# SERVICE BULLETIN REVISION NOTICE

INFORMATION — IGNITION — INTRODUCTION OF A MODIFIED IGNITION LEAD TO ADDRESS  
INSULATION DEGRADATION/CRACKING

Turbojet Engine Service Bulletin No. V2500-ENG-70-1004 Revision No. 1 dated June 12, 2014.

# SERVICE BULLETIN

LOCATION OF IGNITION LEAD — A  
74-21-43-01  
FIGURE 1

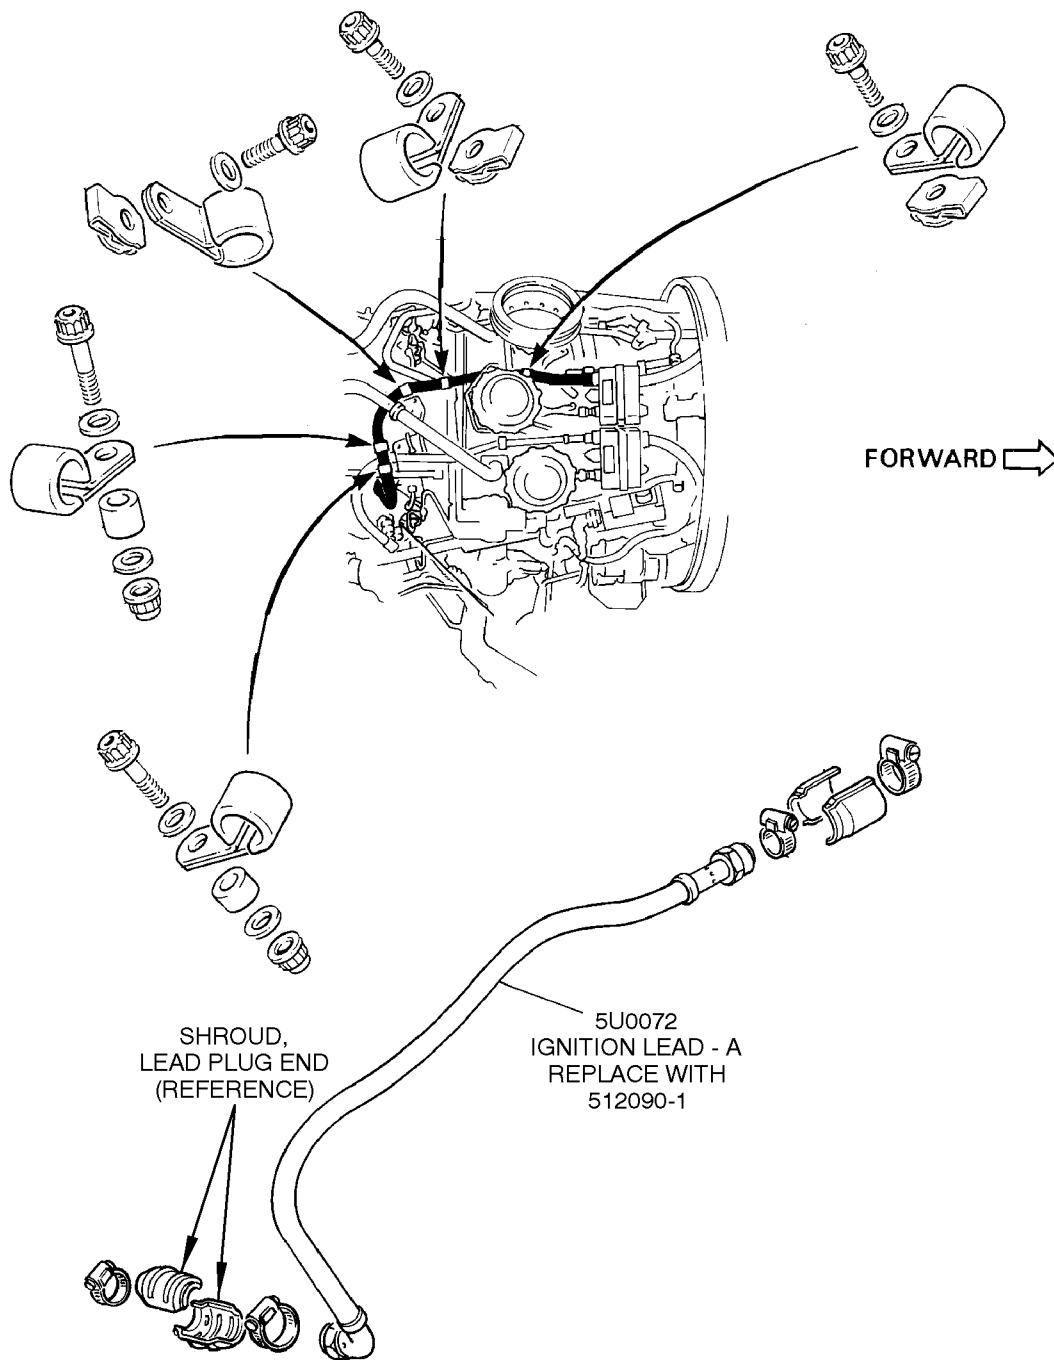
1. For engines installed on aircraft (on wing) do the following procedure: See Figures 1 and 2 for location of parts.
  - A. Refer to Reference 6, Aircraft Maintenance Manual TASK 74-21-43-000-010-A for removal of both V2500-A1 Ignition Leads, PN 5U0072 or TASK 74-21-43-000-010-B for removal of both V2500-A5 Ignition Leads, PN 5U0072.
  - B. Refer to Reference 6, Aircraft Maintenance Manual TASK 74-21-43-400-010-A for installation of both V2500-A1 Ignition Leads, PN 512090-1 or TASK 74-21-43-400-010-B for installation of both V2500-A5 Ignition Leads, PN 512090.
2. For engines removed from aircraft (off wing) do the following procedure: See Figures 1 and 2 for location of parts.

- A. Remove the High Energy Ignition Harnesses: Refer to Reference 5, Engine Manual TASK 72-00-40-020-003-A00 (for A1) or TASK 72-00-40-020-003-B00 (for A5).
    - (1) Remove the 2 Ignition Leads, PN 5U0072 and replace in sets with PN 512090-1.
  - B. Install the High Energy Ignition Harness: Refer to Reference 5, Engine Manual TASK 72-00-40-420-095 (for A1), or TASK 72-00-40-420-224 (for A5).
    - (1) For additional clarity on the A5 engines refer to Reference 9, Service Bulletin V2500-ENG-79-0088.
    - (2) For additional clarity on the A1 engines refer to Reference 8, Service Bulletin V2500-ENG-79-0087.
3. Recording Instructions
    - A. A record of accomplishment is required.
